# SIMPLY SELF STORAGE

**Applicant's Request:** Specific Parcel Master Plan (SPMP) approval for 83,100 square foot personal storage facility within the Education Village PD.

Updated: October 31, 2014

# PROPOSED SITE PLAN

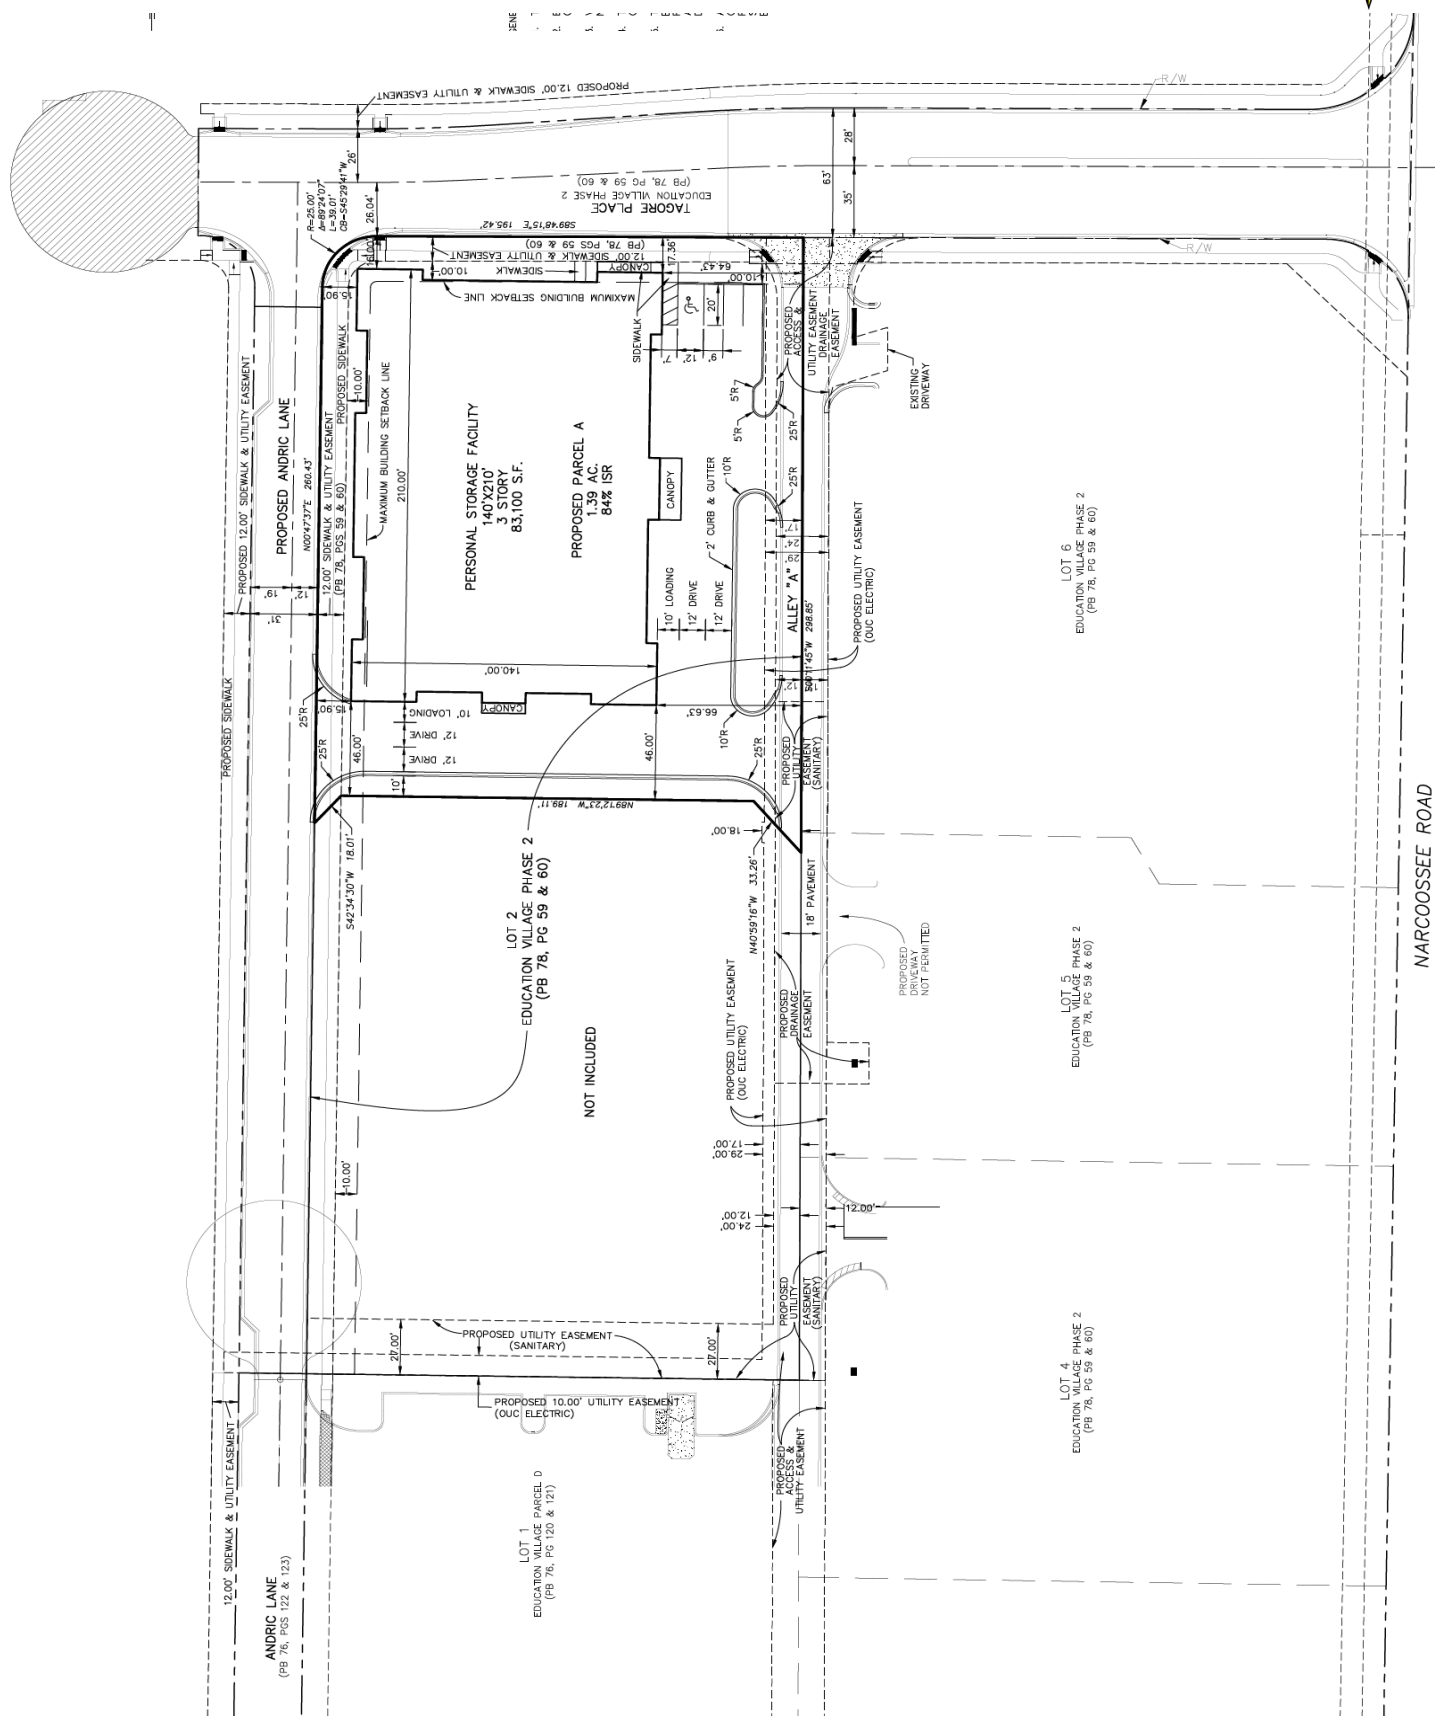
The SPMP site plan does not depict a dumpster on the site. A dumpster shall be located on the property and must comply with Transportation Condition #9 on page 11 of this report.

Parking stalls shall have a minimum width of 9 feet, and 18.5 feet in depth. As shown, the 20' length would meet this requirement.

The final site plan shall show the location and size of the on-site solid waste compactor(s) / dumpster(s) with concrete pads, and enclosures with doors. The solid waste container(s) shall not be located adjacent to any single family houses or directly adjacent to the public street. Dumpsters shall be located to provide a minimum 50 feet of clear backup space and constructed per Orlando Engineering Standards Manual (ESM) requirements, OR documentation shall be provided from the City's Solid Waste Division indicating curb pick-up or other approved arrangement.

# ARCHITECTURAL ELEVATIONS

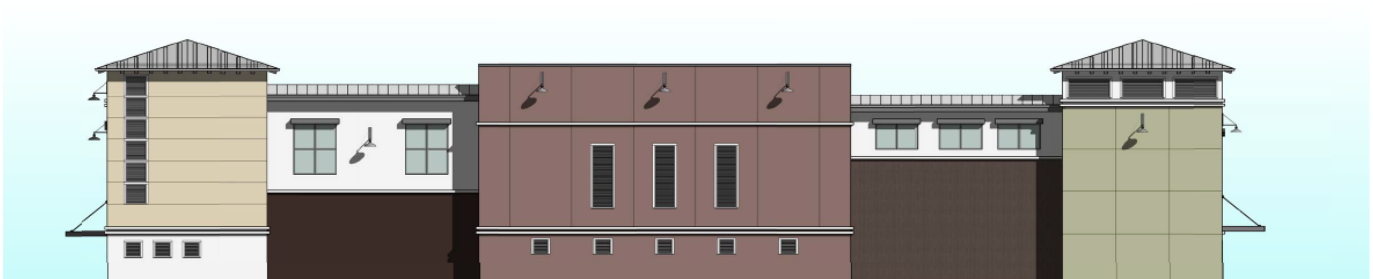
- The proposed elevations appear to have met this condition, however, the scale of the base, windows, and other details are out of proportion. This building is designed as a three-story building; however, the facades are designed with proportions that exaggerate the elevations of a one or two story building. This affects the massing of the building as well, and makes a large building appear even larger, due to the incorrect proportions. Each façade, or portion of façade shall express the 3 levels of the façade. Revisions to the elevations showing appropriately scaled windows and other façade details shall be submitted.

- Building bays should be a maximum of 30 feet in width. Bays should be defined by vertical architectural features such as columns, piers, and fenestration. The projections and recesses of the facades, along with the roof parapet changes are appropriate to help break down the massing of the building. These elements shall be coordinated with the revised elevations responding to the proportions.

- e. Transparency: Because this is for a personal storage facility that is not typically occupied by people, transparency is not required except in the office area where a minimum 30 percent transparency is required. In lieu of providing transparency, the north and west façades shall include architectural features that make the building look like a 3-story building. The south and east façades shall include similar finishes to create consistency throughout the building. For CPTED purposes, staff recommends including a vision panel in exit doors.
